PRODUCT CHANGE NOTIFICATION (PCN)

A-USB31C-05F-xxx USB Type-C male to Audio Jack Cable

CHANGE NOTIFICATION:	PCN 20230803_A-USB31C-05F-xxx
DESCRIPTION OF CHANGES:	CHANGE OF DATA SHEET CHANGE OF DATA SHEET New Draw.-No. ASS_10356_CAreV03
REASON FOR CHANGE:	CHANGE OF PRODUCT DIMENSIONS, TOLERANCES AND/OR PROPERTIES CHANGE OF PRODUCT DIMENSIONS, TOLERANCES AND/OR PROPERTIES
KEY CHARACTERISTICS OF CHANGE:	Details see page 3
PRODUCTS AFFECTED:	A-USB31C-05F-015 & A-USB31C-05F-150
DATE OF CHANGE AND IMPLEMENTATION:	CHANGE: WEEK 31 / YEAR 2023 IMPLEMENTATION: 08.03.23
RESPONSE:	NO RESPONSE TO THIS NOTIFICATION IS REQUIRED

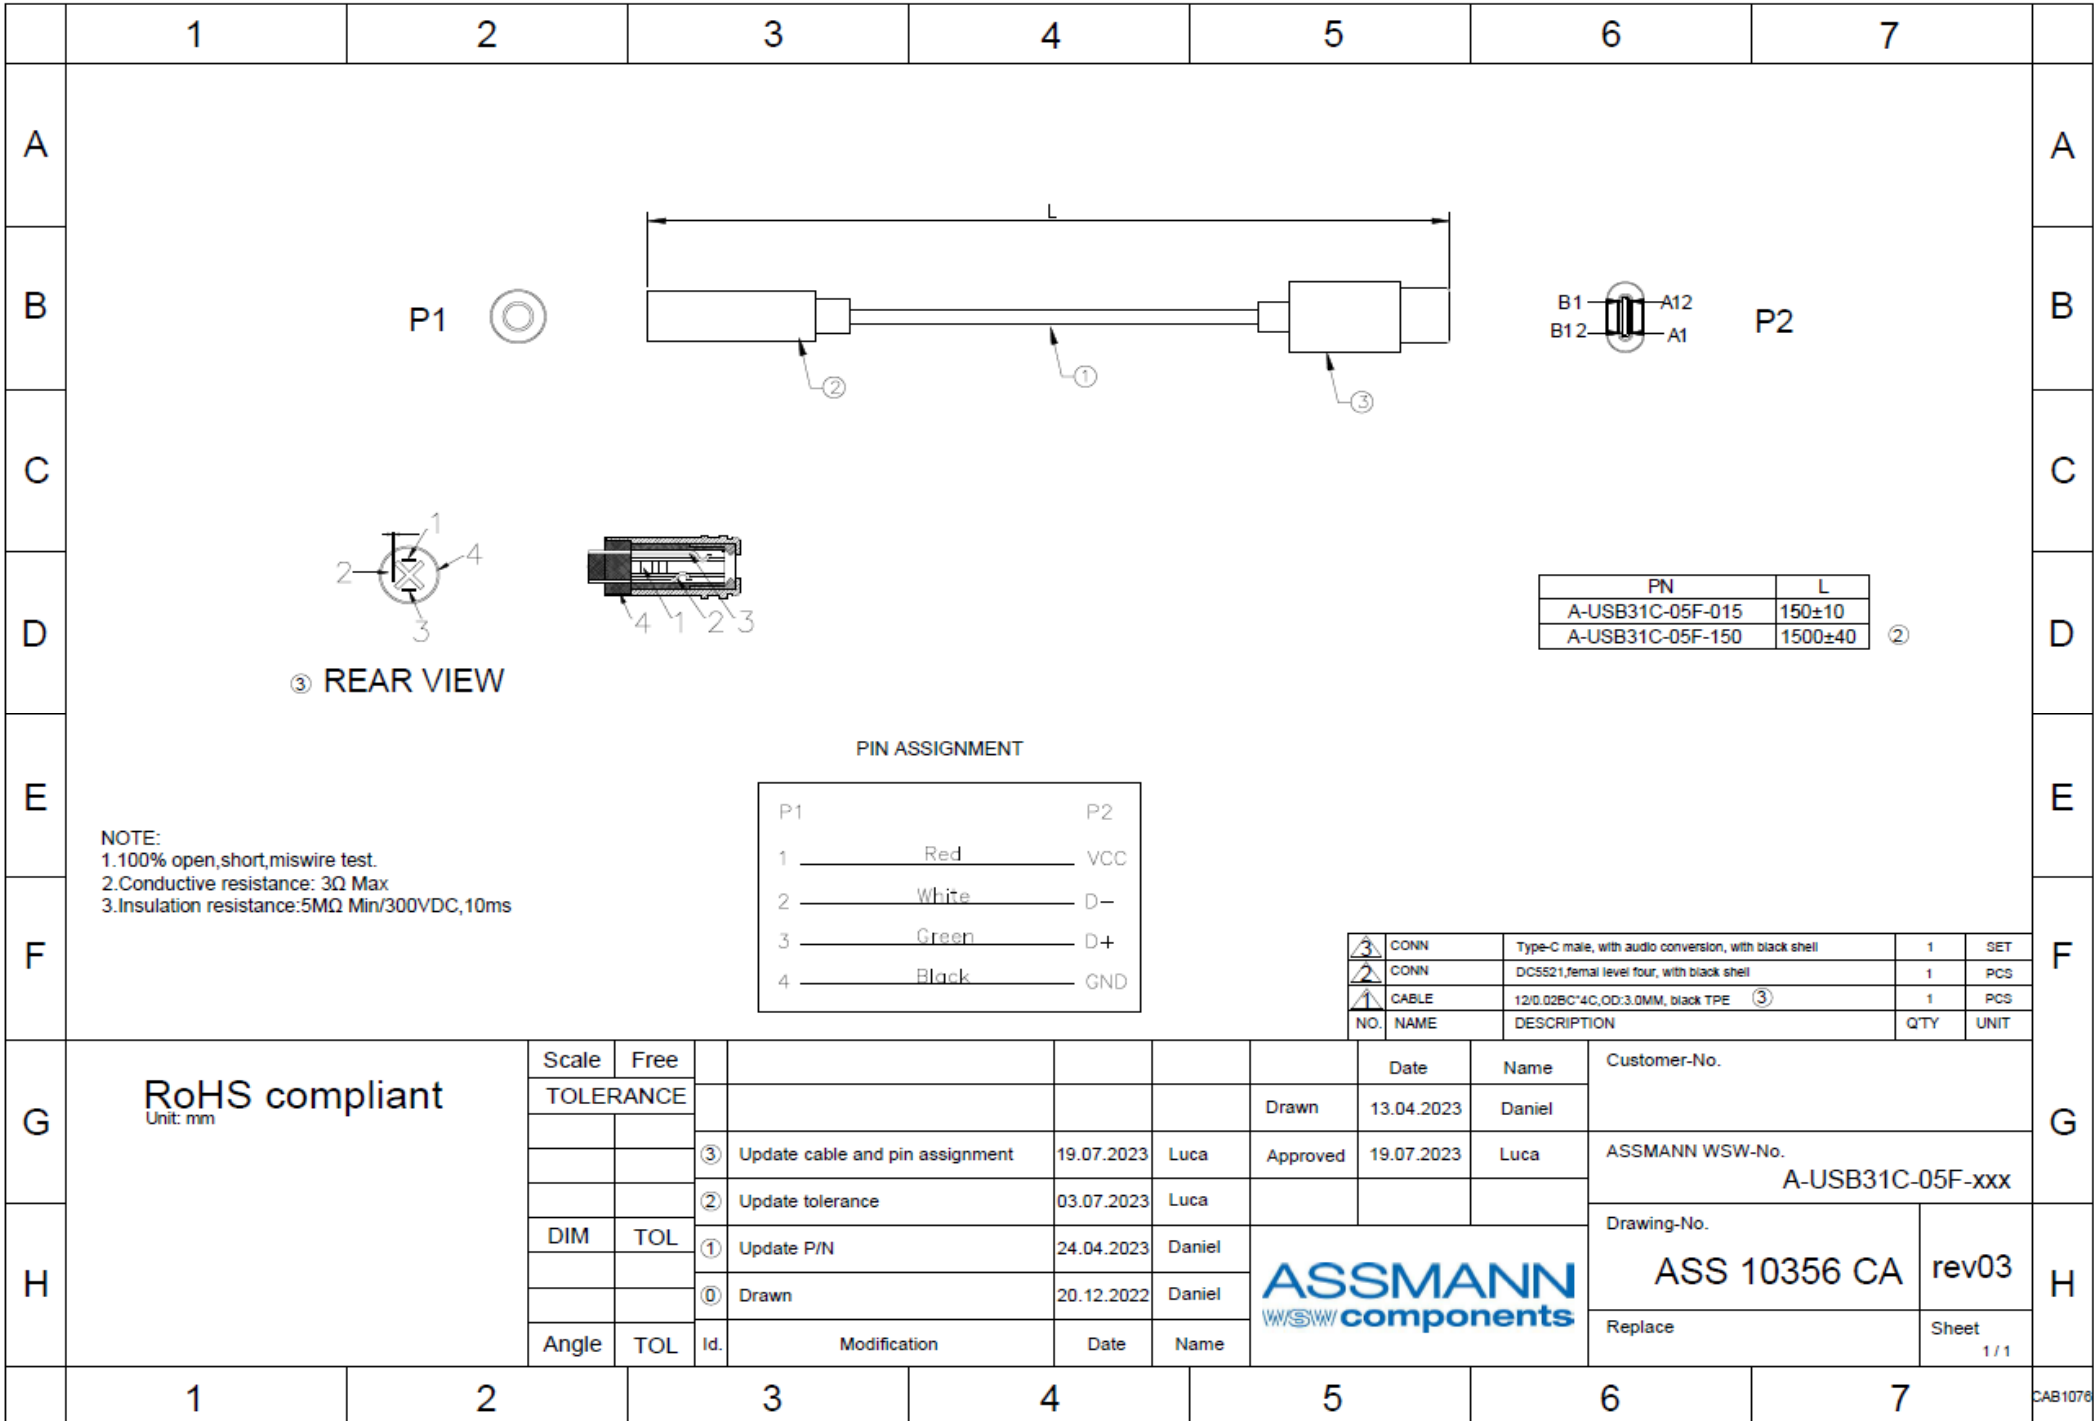
A-USB31C-05F-xxx OLD VERSION	A-USB31C-05F-015 & A-USB31C-05F-150 NEW VERSION						
<p>Wiring:</p>  <p>REAR VIEW</p> <p>Cable:</p> <table border="1" data-bbox="172 1288 774 1332"> <tr> <td></td> <td>CABLE</td> <td>12/0.02BC*4C, OD:2.8MM, black PVC</td> </tr> </table>		CABLE	12/0.02BC*4C, OD:2.8MM, black PVC	<p>Wiring:</p>  <p>③ REAR VIEW</p> <p>Cable:</p> <table border="1" data-bbox="869 1288 1460 1332"> <tr> <td></td> <td>CABLE</td> <td>12/0.02BC*4C, OD:3.0MM, black TPE ③</td> </tr> </table>		CABLE	12/0.02BC*4C, OD:3.0MM, black TPE ③
	CABLE	12/0.02BC*4C, OD:2.8MM, black PVC					
	CABLE	12/0.02BC*4C, OD:3.0MM, black TPE ③					
<p>FOR DETAIL, PLEASE TAKE ATTACHED NEW DRAWING: FOR REFERENCE</p>
